HISTORIC LANDMARK COMMISSION
STAFF REPORT

TRACY AVIARY MACAW and KING VULTURE
EXHIBIT

PLNHLC2013-00785

October 3, 2013

Attachment B
Elevations

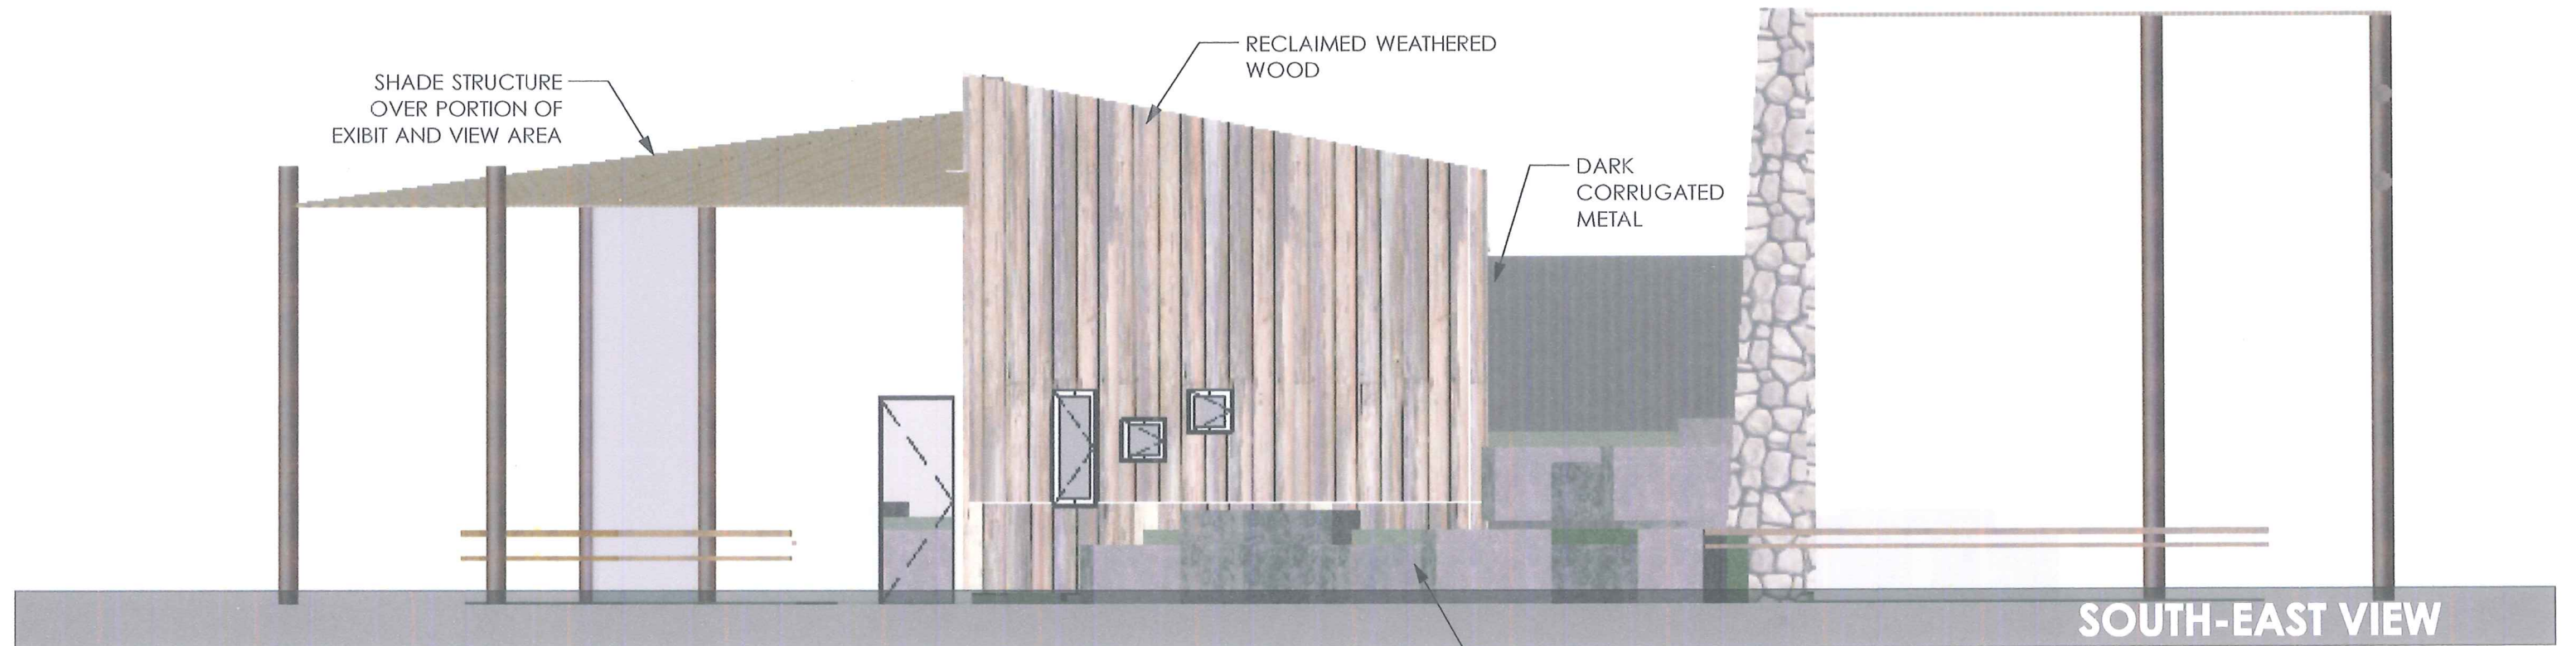
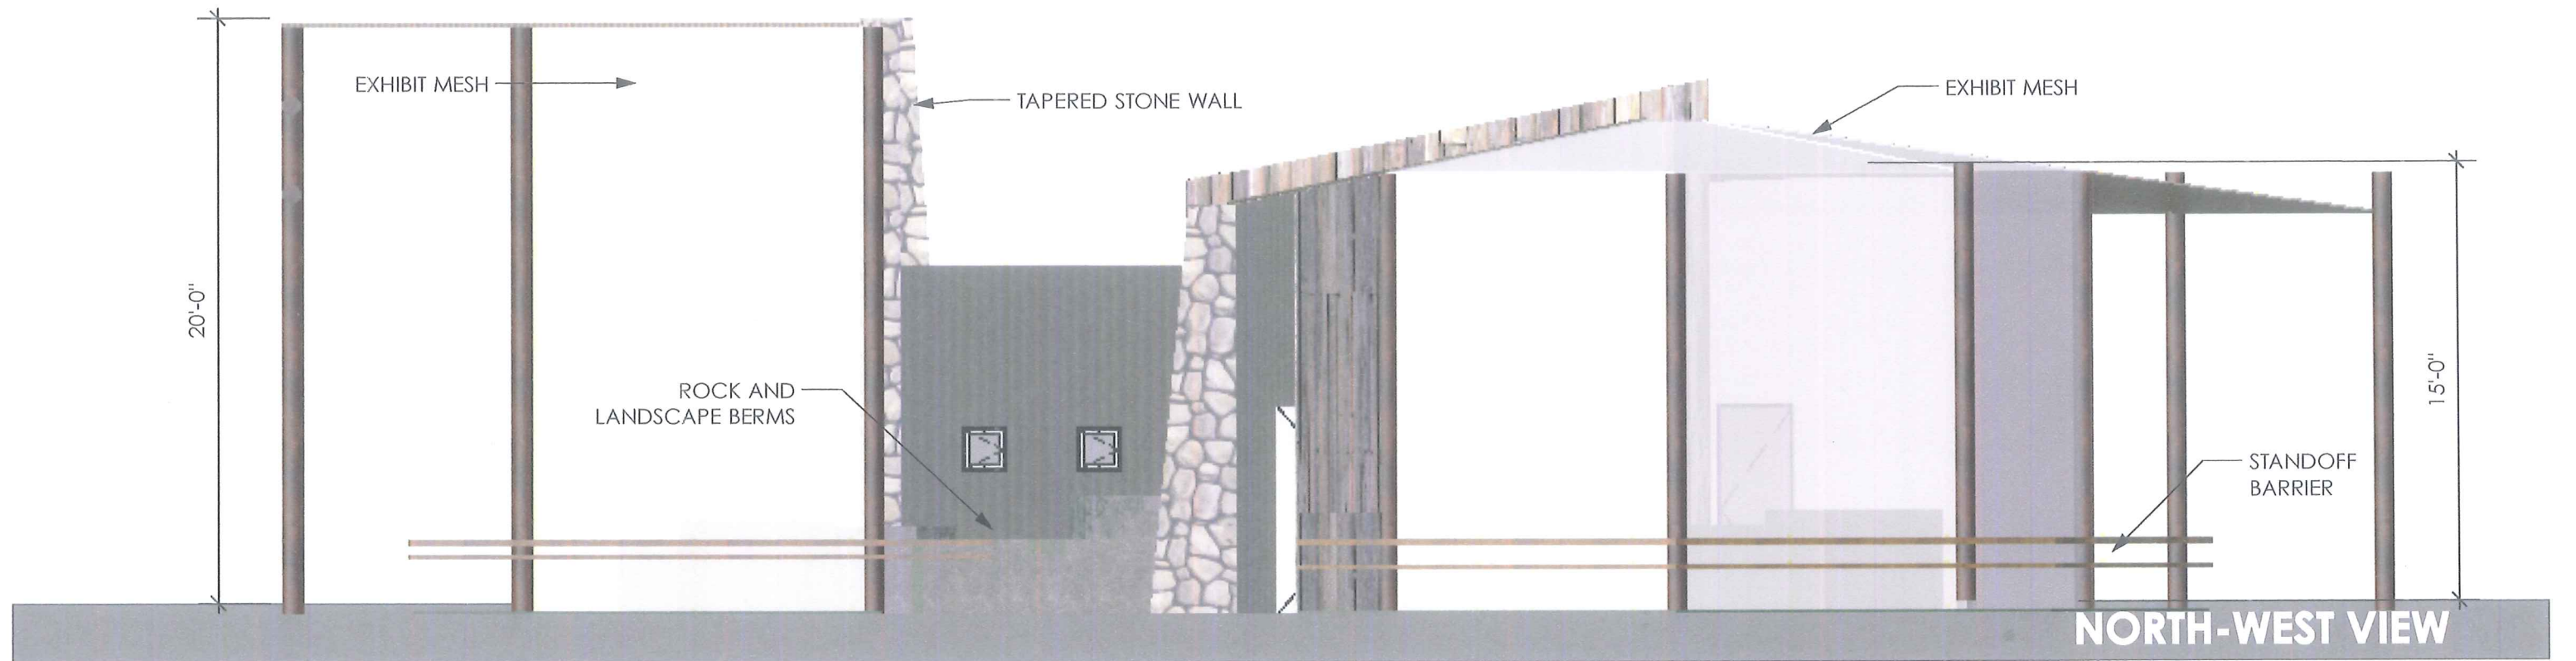
Analysis: The architectural composition of the building is similar in design and materials to other display buildings in the aviary. The display areas are transparent with no traditional features such as windows, doors and entry porches with the solid mass of the building recessed. Nonetheless, the architectural design is

appropriate for its context/location and proposed use. The rhythm of solids to voids along the various facades is dominated by the voids, and is consistent with newer bird enclosures in the aviary. The wire mesh is designed to provide visitors with an unencumbered view of the birds, while the enclosed building provides caretakers and aviary employees with an area to care for the birds and protect them.

Finding: Staff finds that the composition of the principal facades is compatible with the surrounding architecture in the Tracy Aviary. The design of the structure is suited for the unique use for which it will be employed, and is built in an unobtrusive way.

1. Types and styles of materials shall be reviewed by staff for final approval prior to installation on the building.
2. Only natural finish materials will be used. No imitation materials, such as but not limited to, cultured stone, cement based siding, or vinyl siding are allowed.
